3.0 COMMENT LETTERS AND RESPONSES

1. COMMENTS RECEIVED ON THE DRAFT VISTA CANYON EIR

Figure 1: Chloride Concentrations in Locations throughout the State Water Project

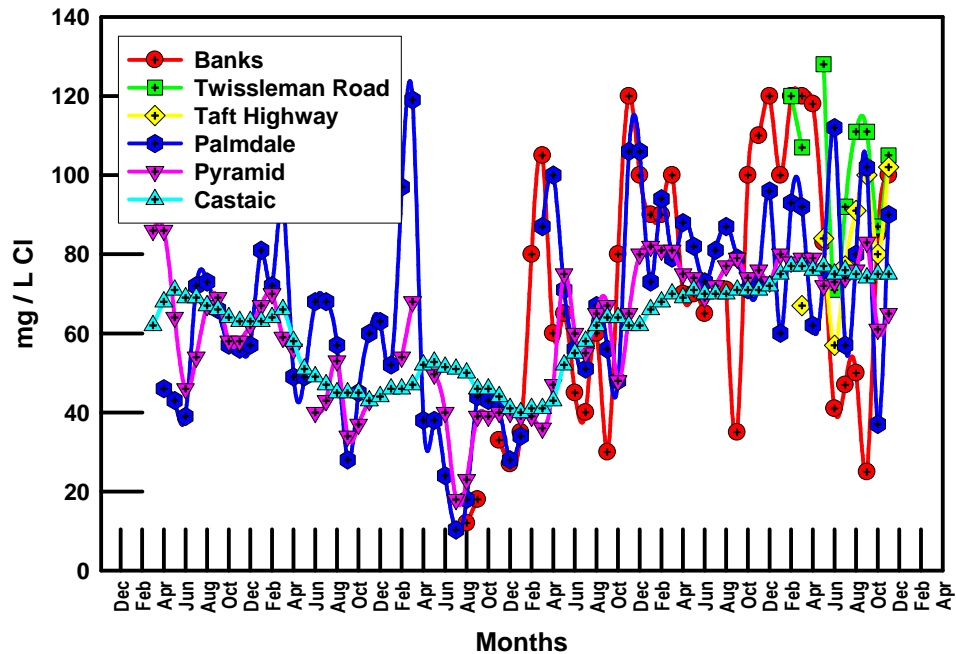
SWP water intended for use by the Castaic Lake Water Agency (CLWA) is conveyed through the West Branch of the California Aqueduct to Quail and Pyramid Lakes and then to Castaic Lake, the terminus for the West Branch. Chloride concentrations in SWP water at Castaic Lake have been consistently below 80 mg/L since 2004 based on data collected by CLWA (see **Figure 1**, below). This water quality is well below the adopted site-specific objectives (SSOs) for Santa Clara River Reach 5 (e.g., 150 mg/L as a 12-month rolling average) and the lower reaches of the Santa Clara River (e.g., 117 mg/L as a three-month rolling average at Reach 4B, downstream of Blue Cut). Therefore, SWP water is not expected to cause the Santa Clarita Sanitation District to fail to meet the TMDL for chloride.

The Los Angeles Regional Water Quality Control Board (RWQCB) first adopted a TMDL for chloride in the Upper Santa Clara River in October 2002 (Resolution No. 2002-018). On May 6, 2004, the RWQCB amended the Upper Santa Clara River chloride TMDL to revise the interim wasteload allocations (WLAs) and implementation schedule (Resolution 04-004). The amended TMDL was approved by the State Water Resources Control Board (SWRCB), Office of Administrative Law, and the US Environmental Protection Agency (USEPA), and became effective on May 4, 2005.
